SUMMARY OF DEFICIENCIES BY BUILDING

AQUATIC FACILITY REVIEW
for
THE CITY OF MINERAL WELLS, TEXAS

October 14, 2019

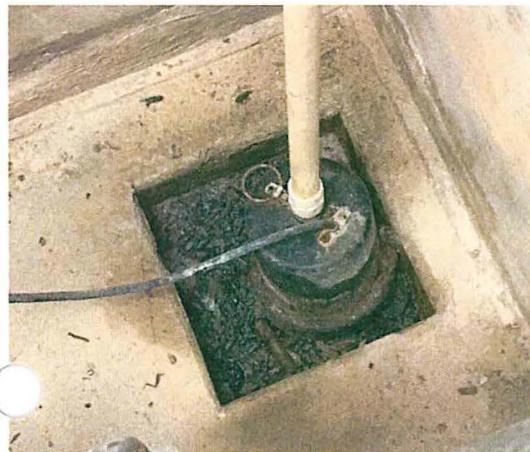
Existing pumps, motors, pump stands and strainers are rusted throughout.

Complete replacement of all pumps, pump motors, pump bases and pump strainers in the pump pit. (3 pumps and 3 strainers total.)

(NOTE: Replacement is not required, but strongly recommended for ease of operation, and for efficiency and longevity of the filtration system.)

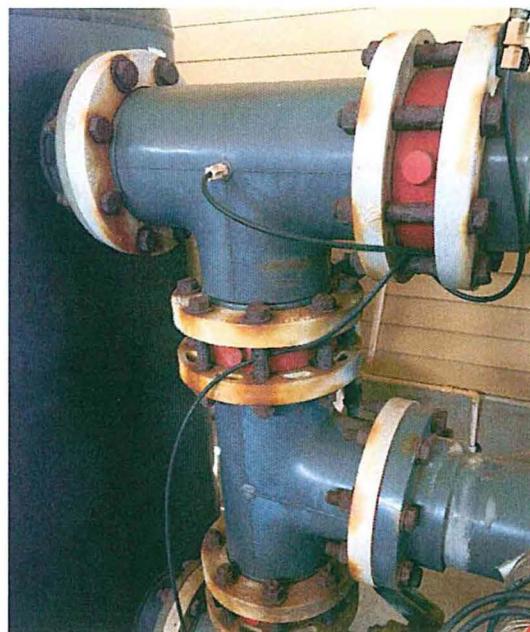
Sump in corner of pump pit is full of debris. Sump pump is probably no longer working. If the pump still runs, it could be damaged or ineffective if ever needed in the case of an emergency.

Clean the sump. Completely replace the sump pump and connect new pump to existing discharge piping.

(NOTE: Replacement is not required, but strongly recommended to ensure proper operation of the system.)

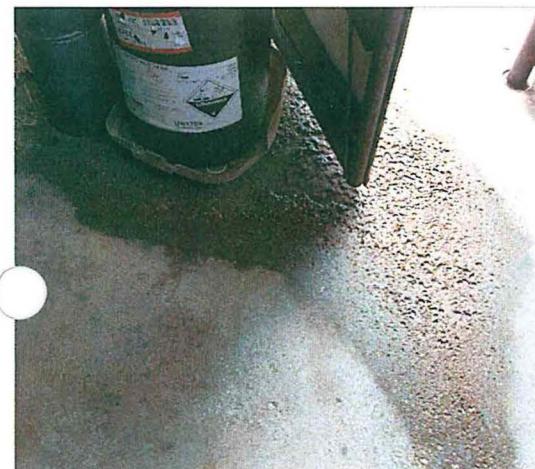
Over the years, it appears several plumbing connections have been made by tapping the main pipe headers. Leaking pipes "sealed" with duct tape and other sub-standard material.

Complete removal and replacement of all piping inside the pool equipment room. New piping will be schedule 80PVC. Pipe connections will be made with standard schedule 80 PVC fittings and saddles; no direct taps. Duct tape and temporary repair materials will be removed and should not be allowed during repairs (whether temporary or permanent repairs).

(NOTE: Replacement of plumbing is not required, but strongly recommended for ease of operation, and for efficiency and longevity of the filtration system.)

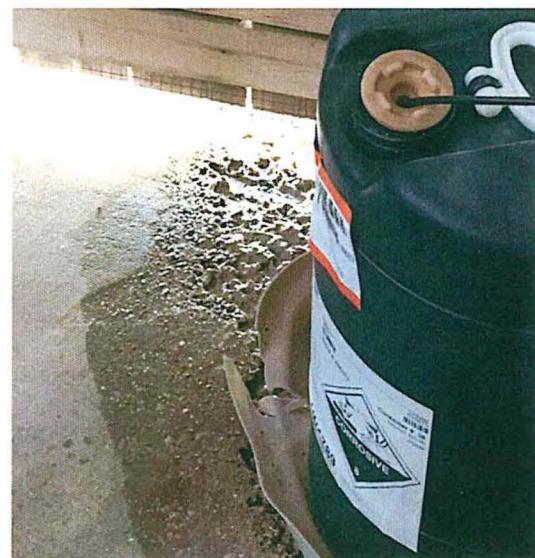
Acid spill(s) with insufficient containment have deteriorated the concrete slab in the equipment room in two locations.

Option 1: Purchase spill containment platforms for both acid containers.

Option 2: Purchase and install briquette-style acid feeders. The acid briquettes are much safer for the pool operators.

(NOTE: This item is not required, but recommended for pool operator safety.)

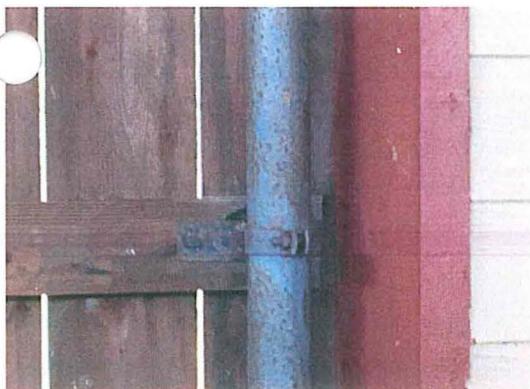
The Accu-Tab chlorinator units currently installed are quickly becoming expiring technology. Several of the internal valves and piping in these units are heavily worn and difficult to repair/replace. Much newer Accu-Tab units are available that operate in a similar fashion but have new, more dependable components.

Remove the existing, obsolete Accu-Tab chlorinators and replace with new Accu-Tab units having the most current technology.

(NOTE: Replacement of Accu-Tab units is not required, but strongly recommended for ease of operation, and for efficiency and longevity of the filtration system.)

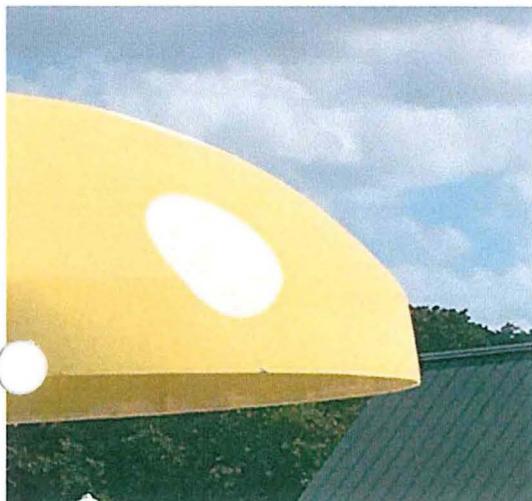
Noticeable discoloration in the plaster finish.

No need to remove or replace the plaster finish due to discoloration. (Aqueous is simply noting this for an accurate record of our findings.)

(NOTE: Removal and replacement of the plaster is not required due to discoloration. Pool operators need to monitor the affected locations and document whether or not the discoloration appears to grow over time. Sources of discoloration could include minerals in the City's incoming water supply, leaves and debris from nearby vegetation deteriorating in the pool, or pool chemistry that is out-of-balance.)

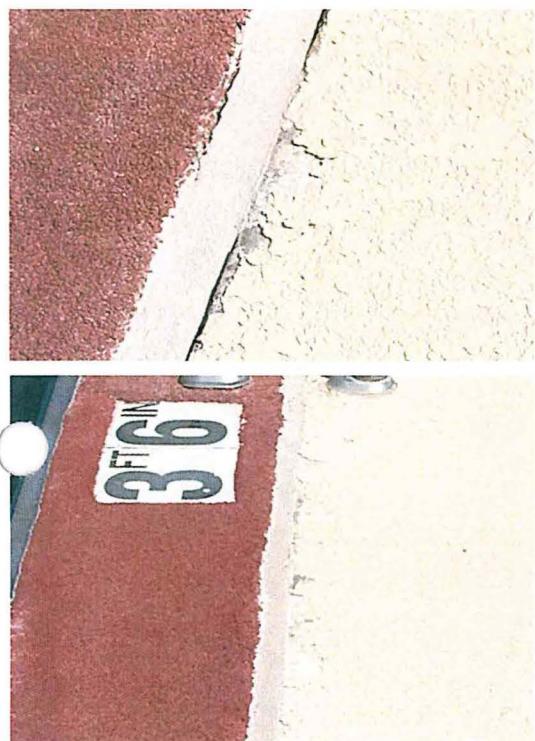
Deck joint sealants are beginning to pull away from the deck in places.

Monitor deck joints and re-seal as needed. (This is an annual maintenance item.)

(NOTE: Upkeep of the deck joints is not a code requirement, but is recommended for both patron safety and for longevity of the facility.)

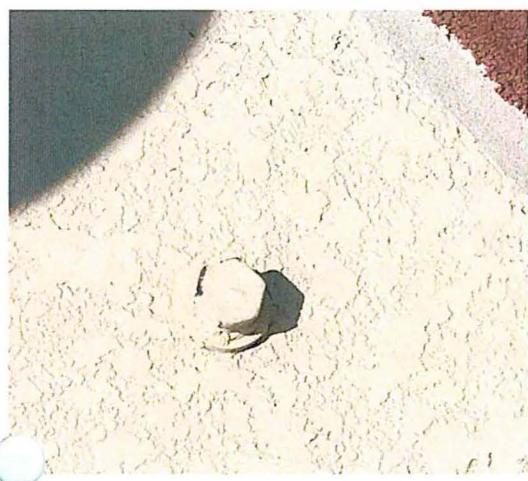
Several locations where the acrylic or cementitious deck coating is beginning to chip or peel.

Monitor these locations and make repairs as needed. (This is an annual maintenance item for deck coatings such as this.)

(NOTE: Upkeep of the deck coatings is not a code requirement, but it is recommended for both patron safety and for longevity of the facility.)

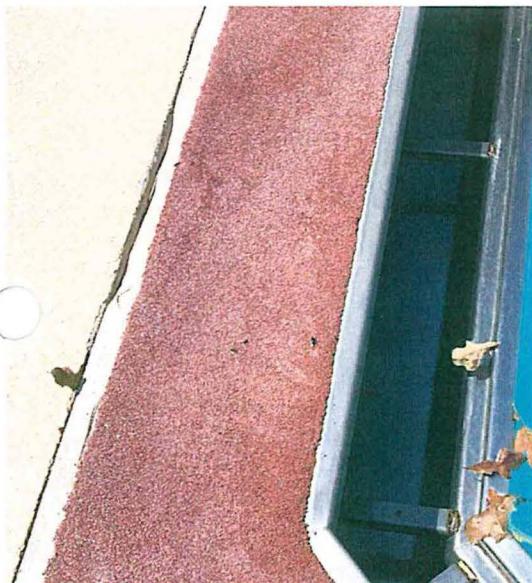
Both the shallow pool and the lap pool are out-of-level. The shallow pool is worse than the lap pool.

Remove the grout around the stainless steel gutter, make adjustments to the rim elevation of the gutter at various locations, and re-grout the gutter in place. Repair the adjacent deck as needed.

(NOTE: Adjustments to the gutters are not required to meet code. Leveling the gutters will make both pools skim properly, but leveling them is not required by a code or to make the pump and filter system operate.)

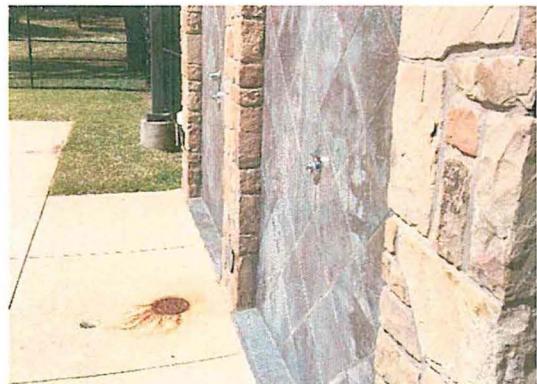
The painted wood framing around the base plates of the shade canopies offers some protection to patrons, but doesn't appear to be completely safe.

Construct/install new base plate covers that are closed on top and cover the anchor bolts and hardware at the column connections to the slab. Paint the base plate covers to match the columns of the shade structures.

(NOTE: New base plate covers are not required per code, but are recommended for patron safety.)

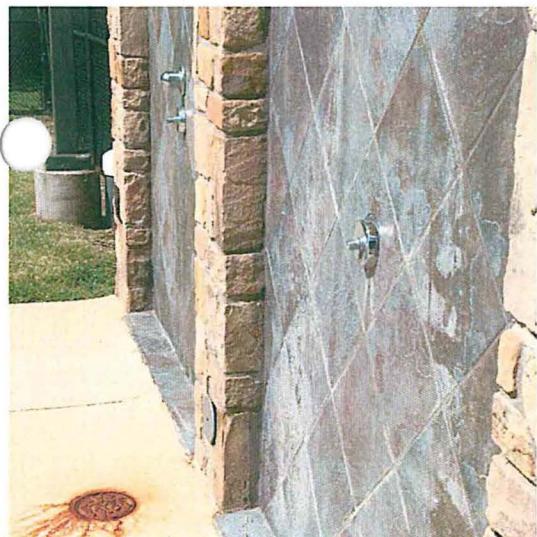
Cast iron water valve cover rusting onto pool deck.

The rust could probably be reduced by sanding or sandblasting the cover and the valve box frame and then painting both with rust-resistant primer and high-build epoxy paint. Clean the adjacent deck thoroughly, and repaint the area that is stained by rust.

(NOTE: This repair is not necessary to meet code. The repair is mentioned because it will improve the appearance of the pool deck, and improve the longevity of the cast iron valve cover.)

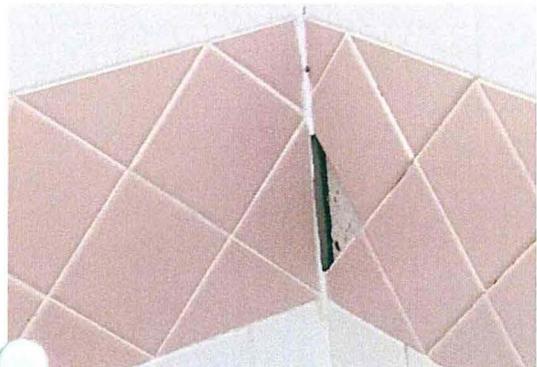
Calcium staining on the tiled shower walls.

Thoroughly clean the shower walls. (This is will an ongoing maintenance item – possibly even something that needs to be included in the *daily* maintenance plan for the facility.)

(NOTE: Cleaning the tile is not required; it is mentioned as it will improve the appearance of the facility.)

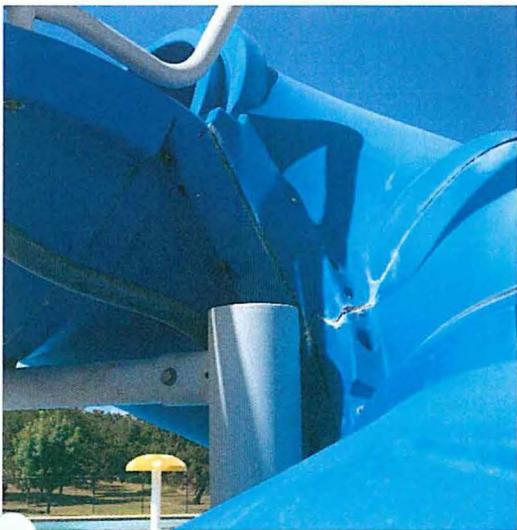
Hardware in shower stall is severely rusted. Hardware in accessible showers does not appear to be ADA- and TAS-compliant.

Replace all shower hardware. Ensure that new hardware installed in accessible shower meets ADA and TAS requirements.
